TECHNICAL BULLETIN	
	October 2008 TB 1987R
Mfg:	GM
Model:	S10
Liter:	3.4L
V I N:	E
Year:	96-05

Revised Cylinder Head Torque Value On
1994-2002 3.1 & 3.4L Engines

Figure 1. Cylinder Head Torque Sequence

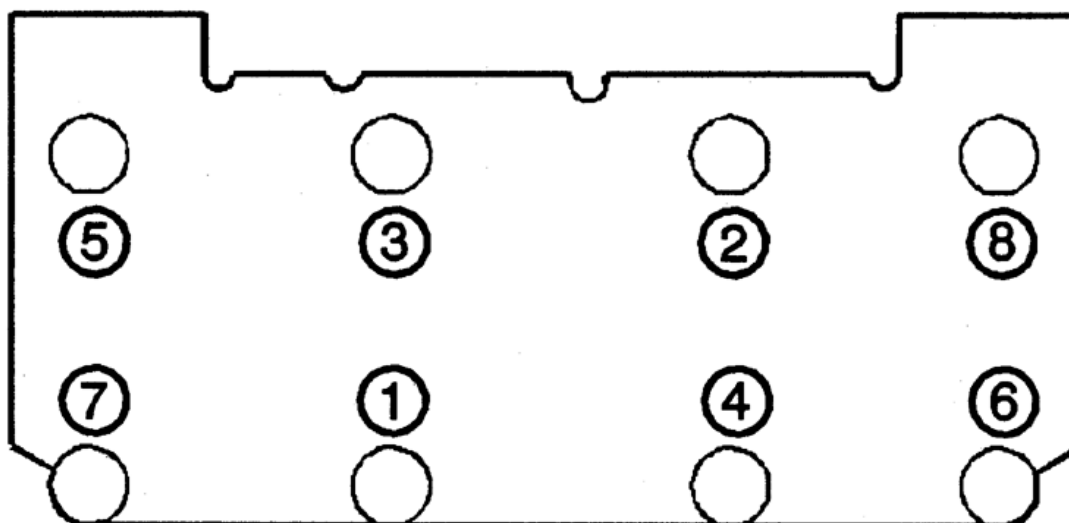
To correctly install the cylinder heads on these engines, GM offers the following information regarding cylinder head torque along with a torque sequence. Tighten the cylinder head bolt to 44 ft/lbs (60 Nm) in the sequence shown in Figure 1. Using a torque angle meter, turn the bolts an additional 95°. If this torque procedure is not followed, engine damage could occur.

Notice: This component uses torque-to-yield bolts. When servicing this component do not re-use the bolts. New torque-to-yield bolts must be installed. Re-using used torque-to-yield bolts will not provide proper bolt torque and clamp load. Failure to install NEW torque-to-yield bolts may lead to engine damage.
